Interactive comment on “A Framework for Automatic Calibration of SWMM Considering Input Uncertainty” by Xichao Gao et al.

Received and published: 4 March 2021

Fig. 1.

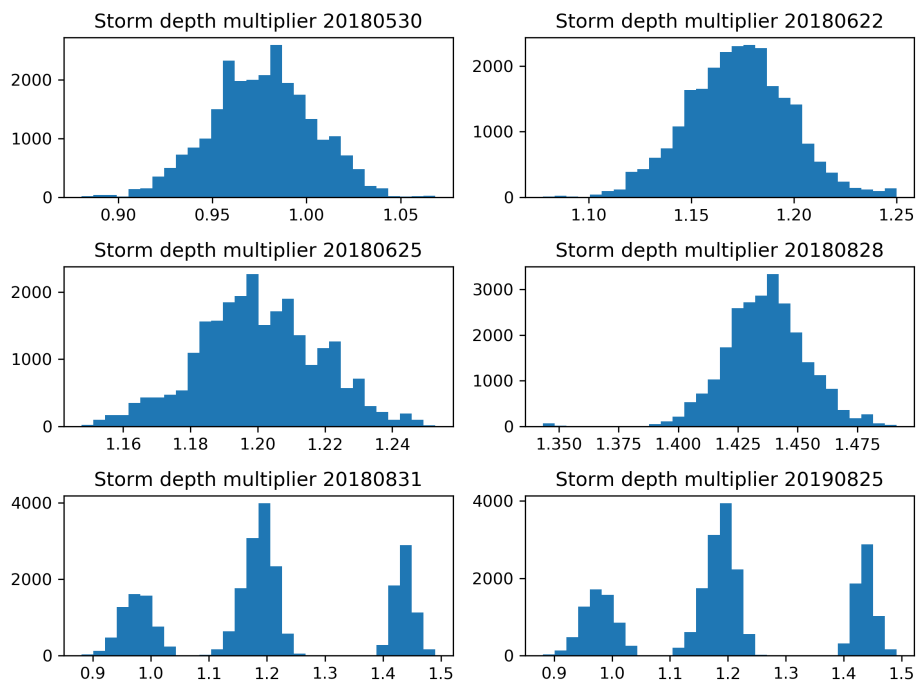
General Comments: This article correctly identifies a knowledge gap in rainfall-runoff models wherein calibration typically considers uncertainty only in the model's parameters, neglecting the uncertainty in forcing data. Additionally, to the best of my knowledge, tying the DREAM calibration methodology to SWMM using a modified PySWMM API is a new and useful contribution. For these reasons, the research that the author's propose is of great interest to the hydrologic community. However, the work done in this paper towards addressing that knowledge gap is unconvincing. The authors aim to “settle [the] problem” of rainfall uncertainty being left out of the calibration process. Yet, at the end of the paper the problem remains unsettled and their arguments undefended. Deficiencies in the simplistic case study and calibration approach call into

question the conclusions that the author's method definitively demonstrates the dominance of forcing data uncertainty in the calibration process. The rainfall uncertainty model itself does not provide convincing evidence for the true magnitude of the rainfall uncertainty issue their calibrated rainfall model implies an underestimation of rain depth greater even than the worst case described in the literature. Given the implications of the assertions posed in the introduction, and the lack of convincing evidence to support those assertions, the contribution of this research to the hydrologic community is hard to justify. Specific Comments:

Reply: Yes, you are right. the reason for the dominance of forcing data uncertainty is that the model structural uncertainty was not considered. In the revised manuscript, we added a first-order autoregressive model to represent the autocorrelation of the residuals and thus to consider the structural uncertainty of the SWMM model. The uncertainty associated with forcing data decreased obviously after considering the model structural uncertainty. See Figure 1, thank you.

that we did not consider the structure uncertainty of the SWMM model and some errors caused by model deficiencies were integrated into the rainfall depth errors; the other reason may be that rainfall intensity is more easily underestimated in urban areas since the measurement of rainfall intensity by rain barrels can be influenced by turbulent flow near the orifice caused by urban wind and shading of rainfall by buildings. In the revised manuscript, the model structure uncertainty was considered. The results illustrated that uncertainties associated with rainfall decrease after considering the model structural uncertainty. See Figure 1, thank you.
